Interim Technical Report

DIABLO CANYON UNIT 1
IDVP VERIFICATION OF CORRECTIVE ACTION

Turbine Building

ITR #56, Revision 0

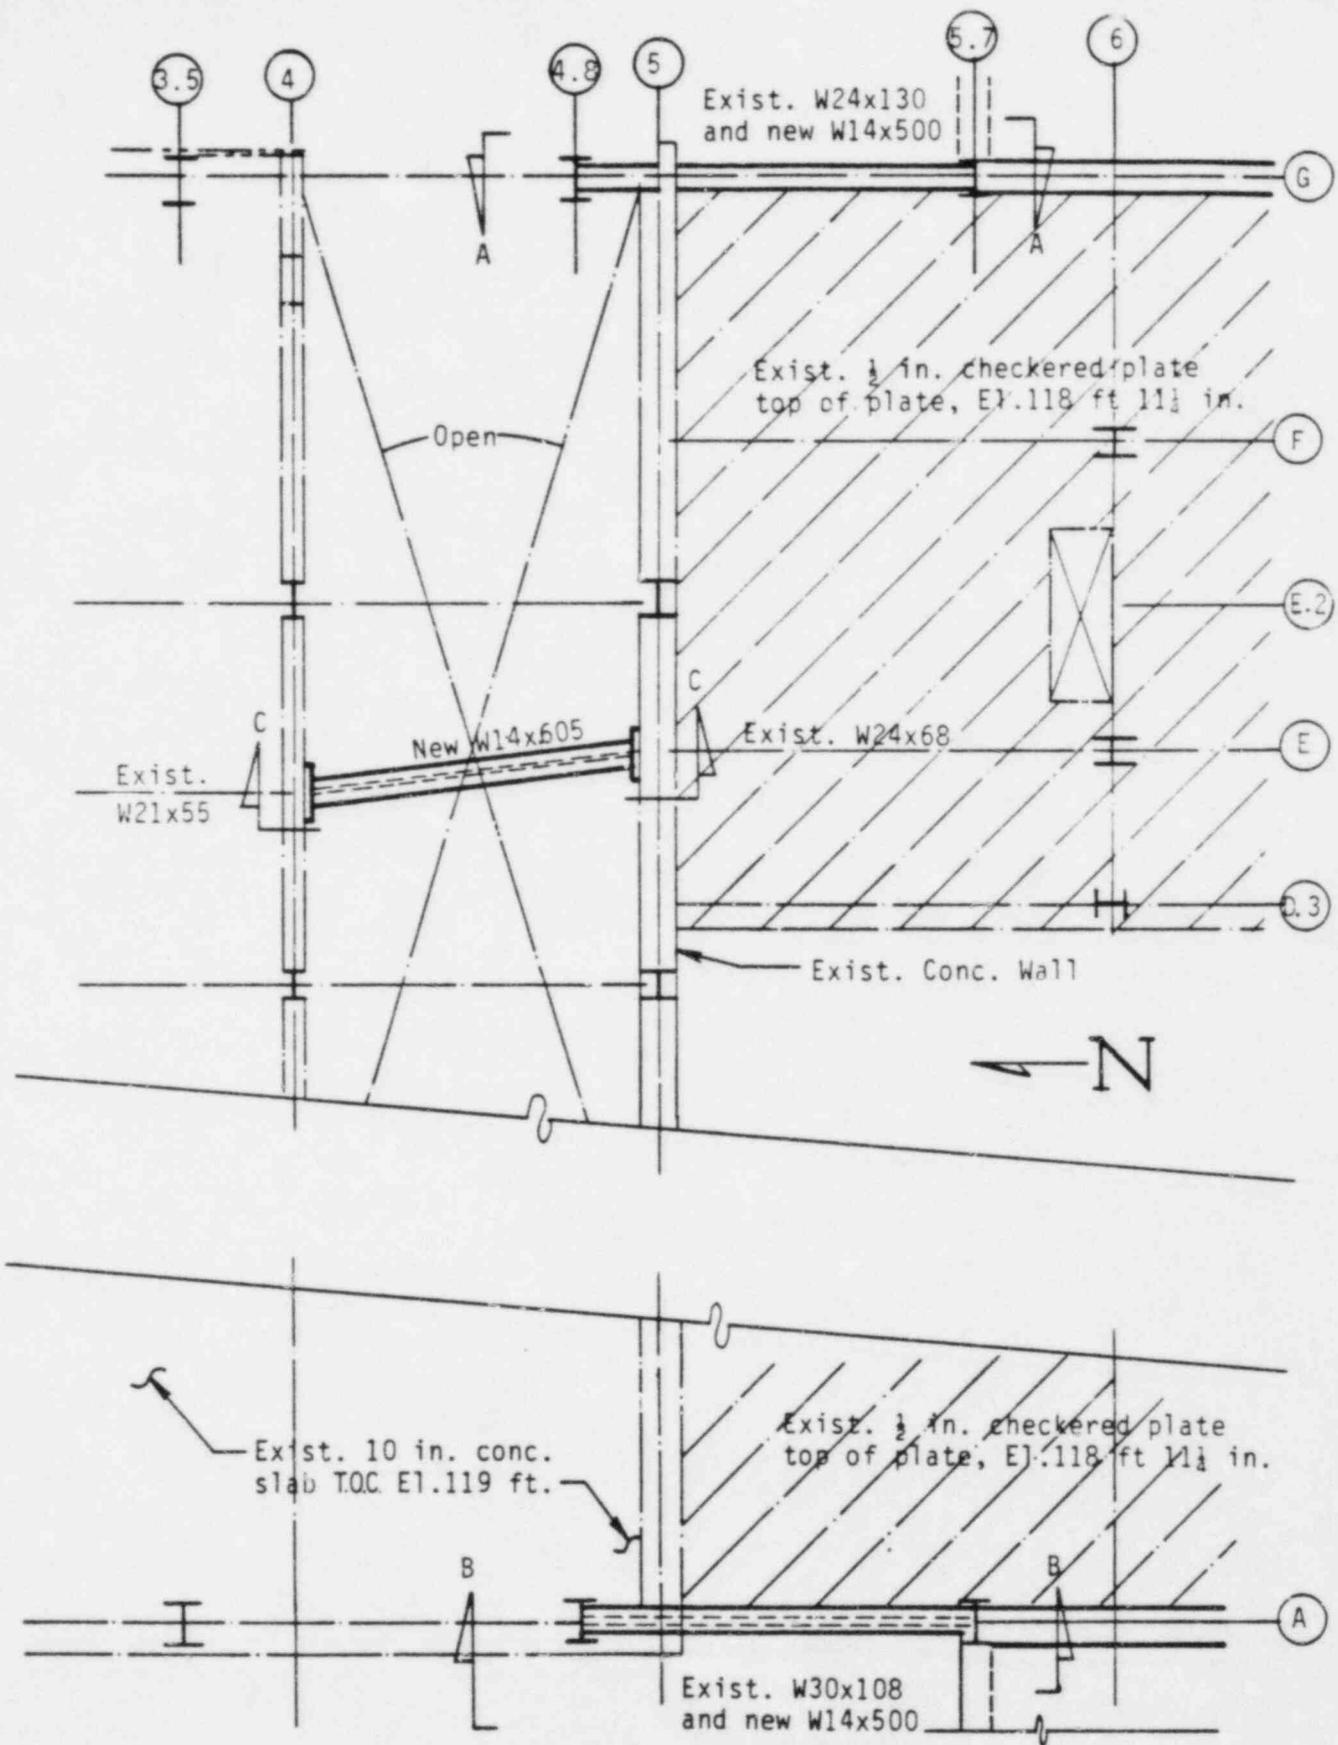
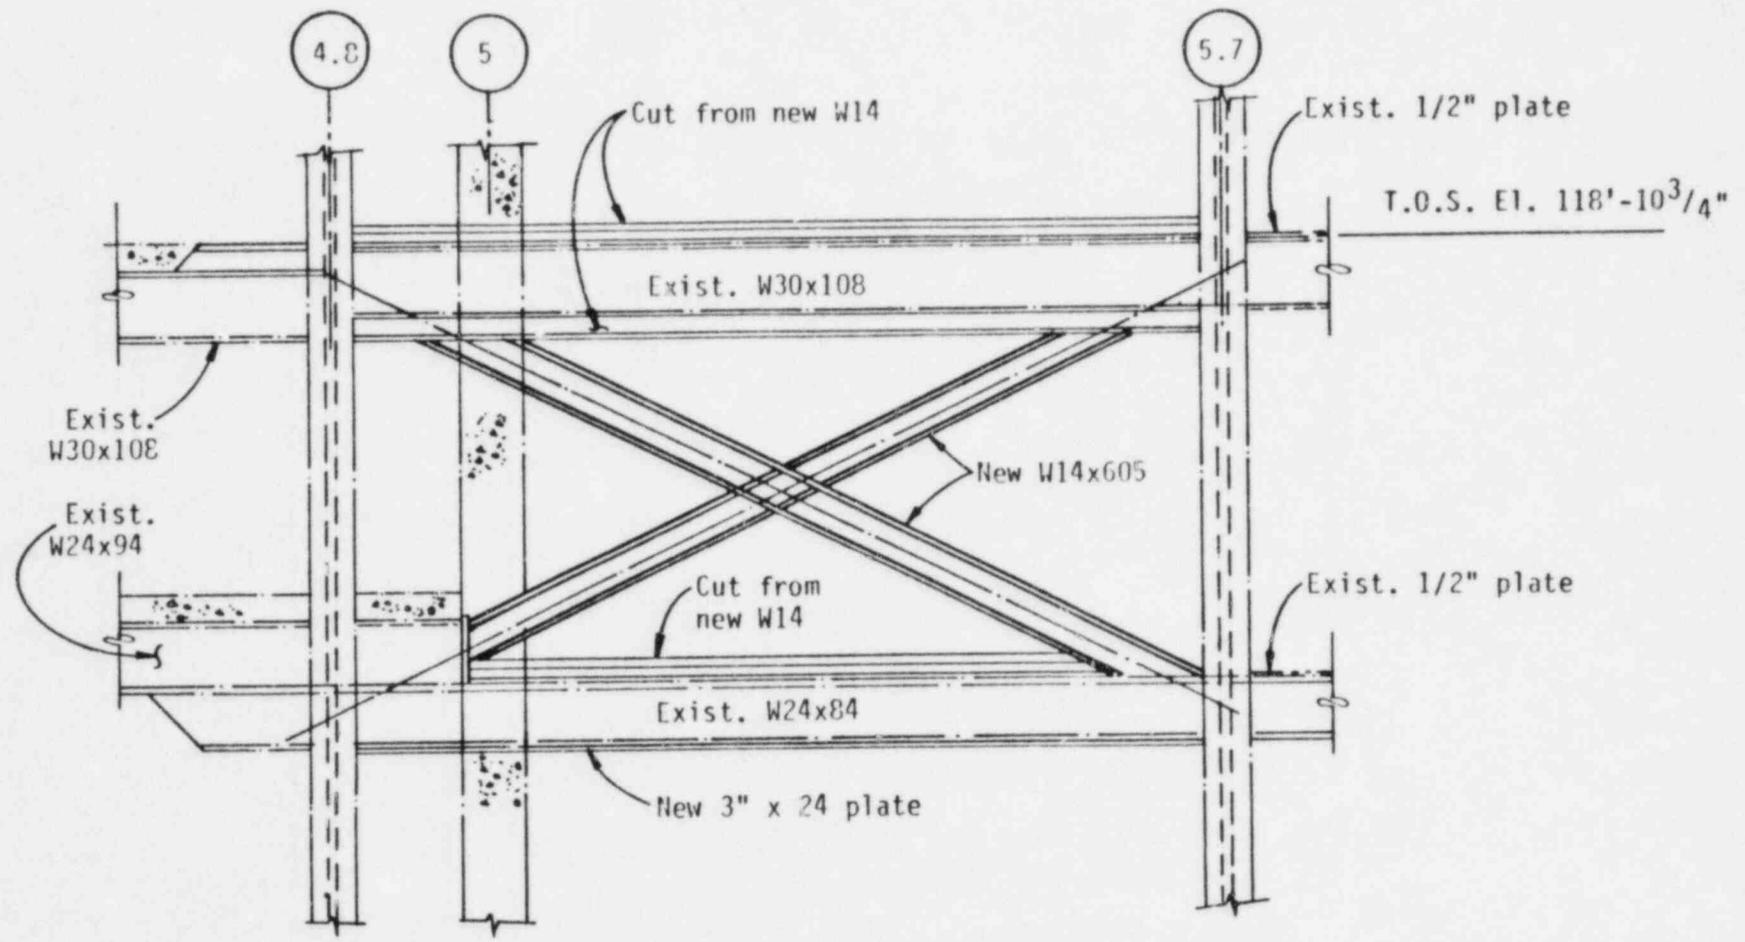
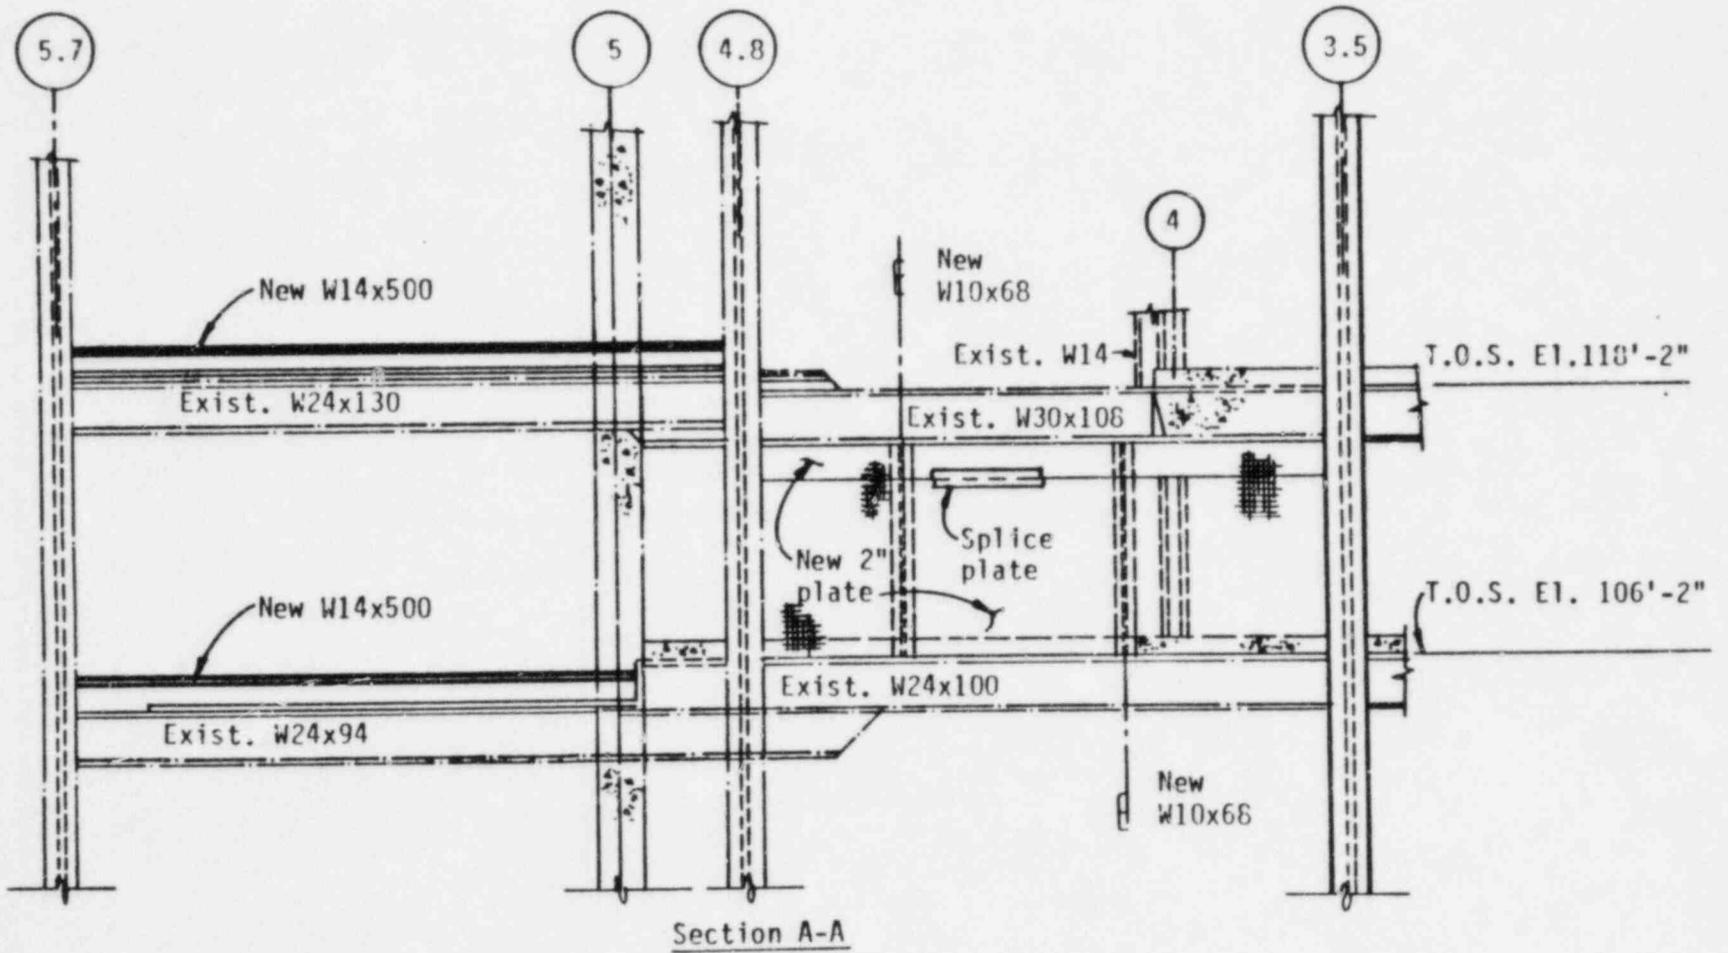
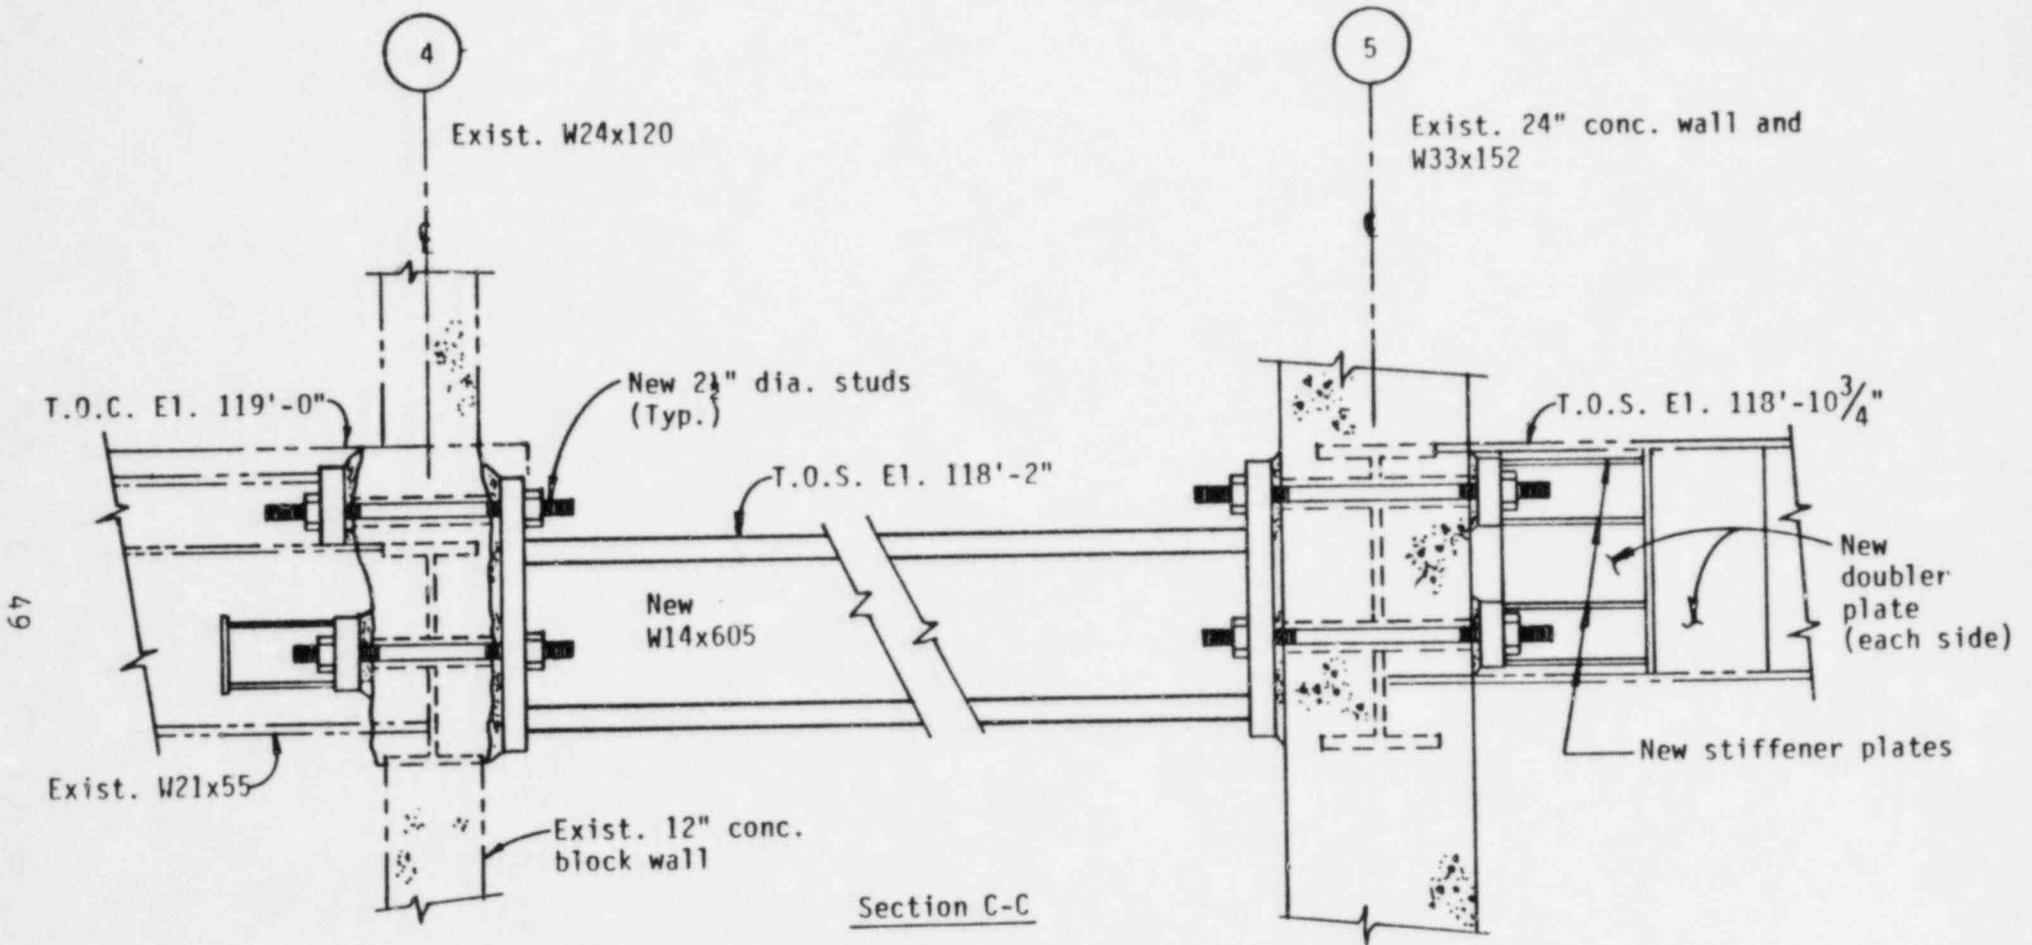
The main modifications designated for the turbine building switchgear area are shown in Figures 7 through 10. A new beam is added at elevation 119 to transfer load through an opening in the diaphragm. An existing beam below the floor diaphragm is strengthened by the addition of plates. These plates contain shear studs used in turn to transfer the horizontal load into the concrete floor diaphragm. This strengthened beam is connected to the beam spanning the opening in the diaphragm. Members and connections are evaluated. Bending loads due to vertical seismic plus dead load are considered. Horizontal loads are taken as the SRSS modal combination from the horizontal model analysis.

The DCP qualification analyses were verified with respect to the design modification drawings and found to be acceptable. Beam interaction formulas reflecting moment magnification effects were not used when adequate lateral support was provided, which is acceptable. Welds were verified to be adequate for transfer of the horizontal shear loads imposed. DCP used peak spectral accelerations when computing bending moments due to the inertia load of the beam, which is conservative. The IDVP verified the spectral acceleration values and found them to correspond to the response spectra for the modified models. Bending moments induced by eccentric axial loads were properly determined and considered as part of the total load.

Figure 14
 Turbine Building Horizontal Model
 Plan at El. 140'-0"

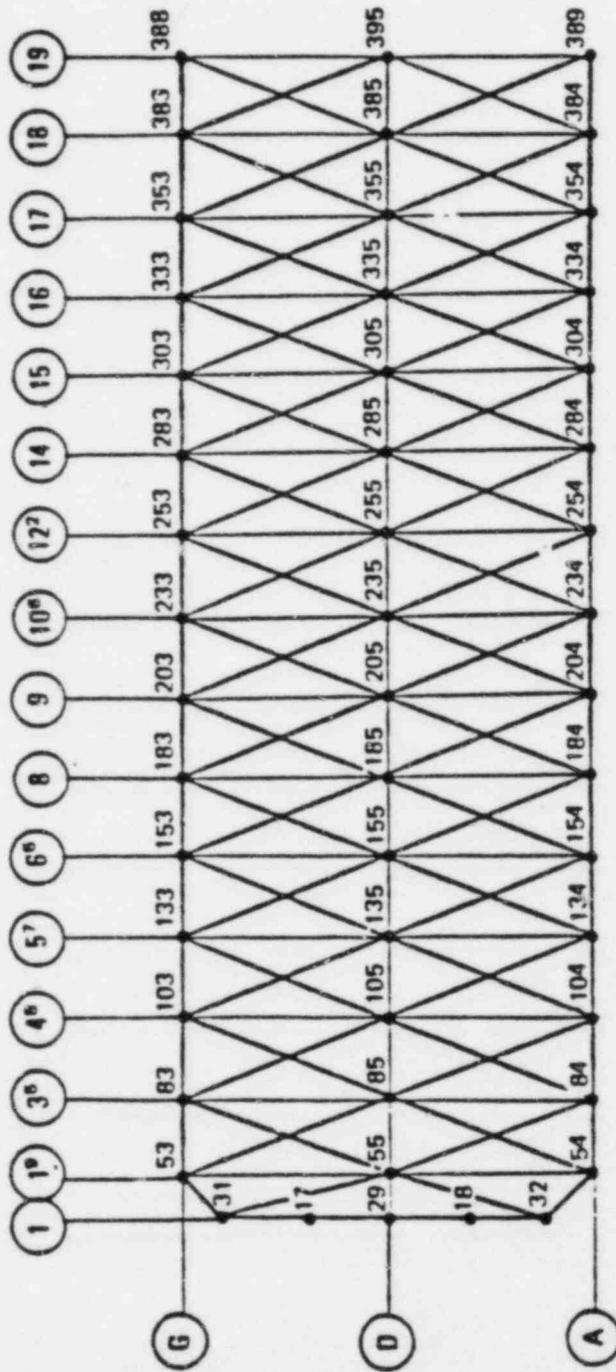
Nodes were defined along column lines A, G and I for Model A, for which these calculations were tabulated. Revisions resulted in the node definition for Model FS12, as shown in Figure 14.
